Product Change Notice (PCN)

PCN Number: PCN-0450022R-01

Product(s) Affected: PJ-074-SMT-TR

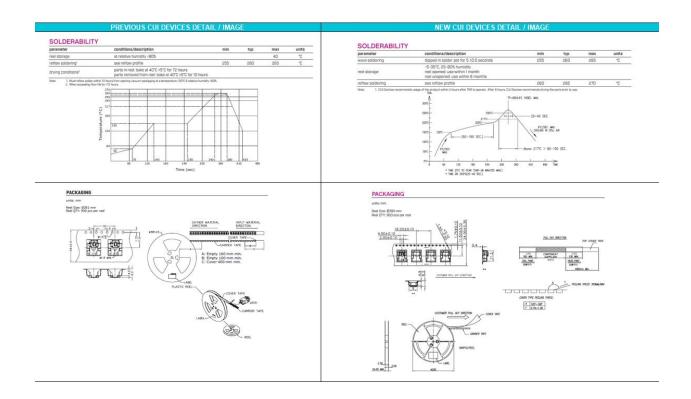
Description of Change: Product re-engineered for improved manufacturability and production yield. See image below as reference for product changes. Cosmetic differences may be visible and do not affect the form, fit or function of the product.

PREVIOUS CUI DEVICES DETAIL / IMAGE				NEW CUI DEVICES DETAIL / IMAGE		
	MATERIAL	PLATING				
terminal 1	brass	gold flash	DESCRIPTION	MATERIAL	PLATING/COLOR	
terminal 2	copper alloy	gold flash	terminal 1	brass	gold flash	
terminal 3	copper alloy	gold flash	terminal 2	copper alloy	gold flash	
plastic	PA6T or equivalent		terminal 3	copper alloy	gold flash	
	o qui raione		housing	PA10T (UL94V-0)	black
